Addendum No. 1 for RFP 02232022 for Mokena SD159 dated 2/23/2022.

Addendum No. 1 issued Monday March 14, 2022

Partial Roof Plan (no scale)

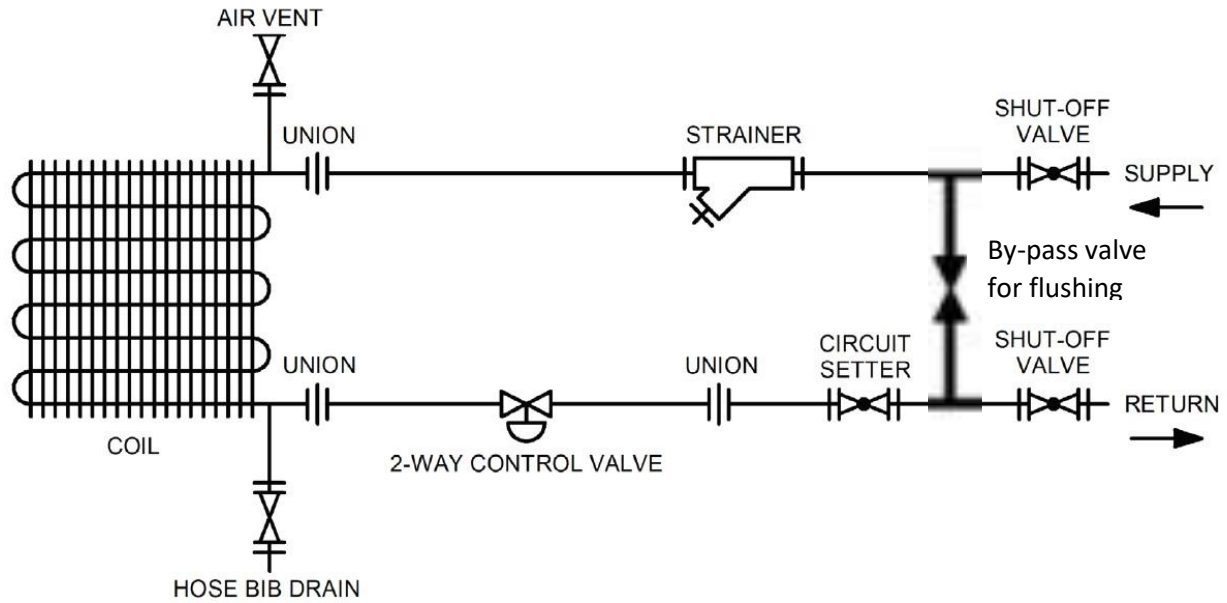
Remove existing condensing unit (qty. 5), and associated electric power circuit, wires and breakers. Evacuate and remove R-22 from site. Patch, seal and re-flash roof.

Typical 2-Way Piping Diagram

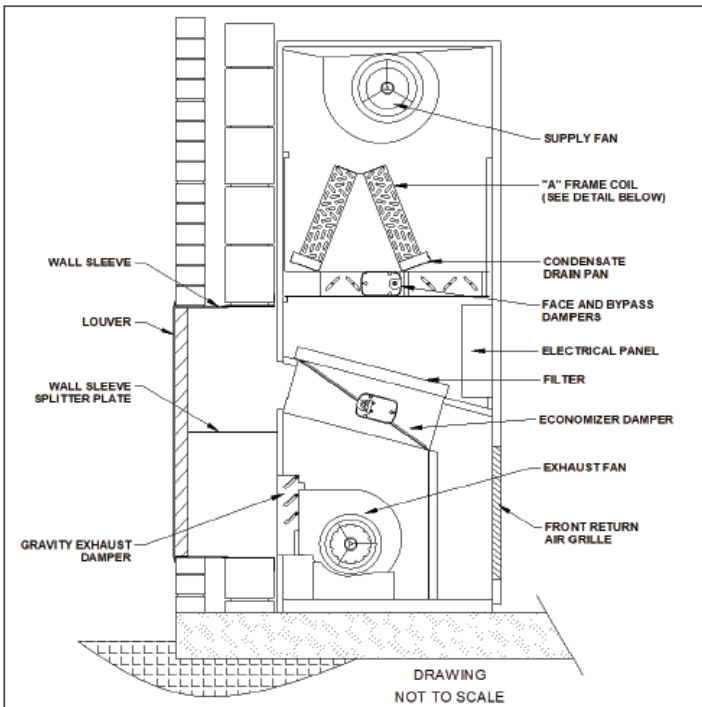
- D. Provide new dual temperature piping from existing 3" taps above the ceiling near courtyard exit door, and route above ceiling and to each new unit vent. Piping shall decrease in size after first two take-offs to 2-1/2", and then to 2" after the last take-off. Terminate piping with shut-off valves and caps in the receiving room, near existing air handling unit S-3 for future connection. Insulate piping per code requirements. Provide by-pass valve and hose connections to accommodate flushing of new piping system before connecting to existing filled piping, see 2-way piping detail below

Louver

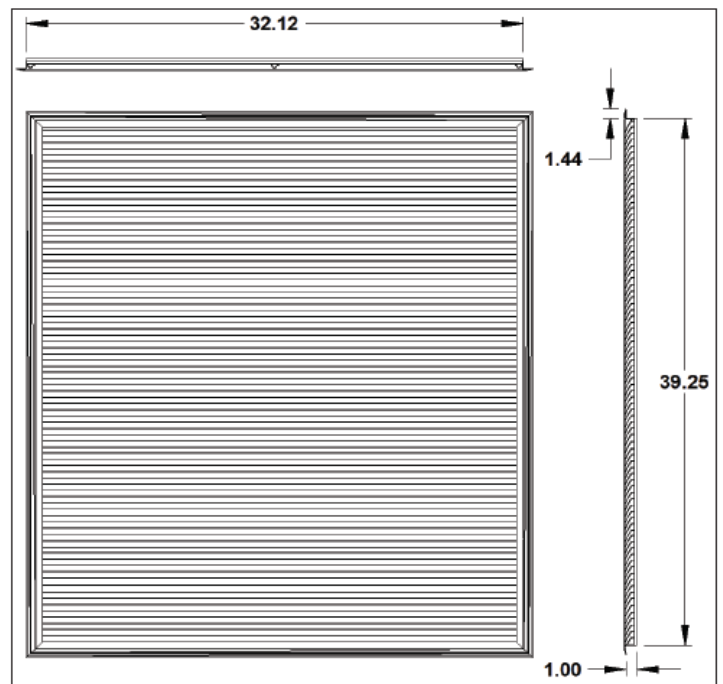
- E. New Unit vents shall have integrated powered exhaust fan system with split louver for intake and exhaust (see detail for larger louver size). Basis of design is Airdale Sentinel UVD50AABCCBNN266N00TNNCN. Alternate manufacturers may be considered for approval by ESG. Units shall be 120V/1ph, and electric panels/wiring shall be modified as required to power the unit properly.

NOTE: Verify louver size with unit vent manufacturer before final order.
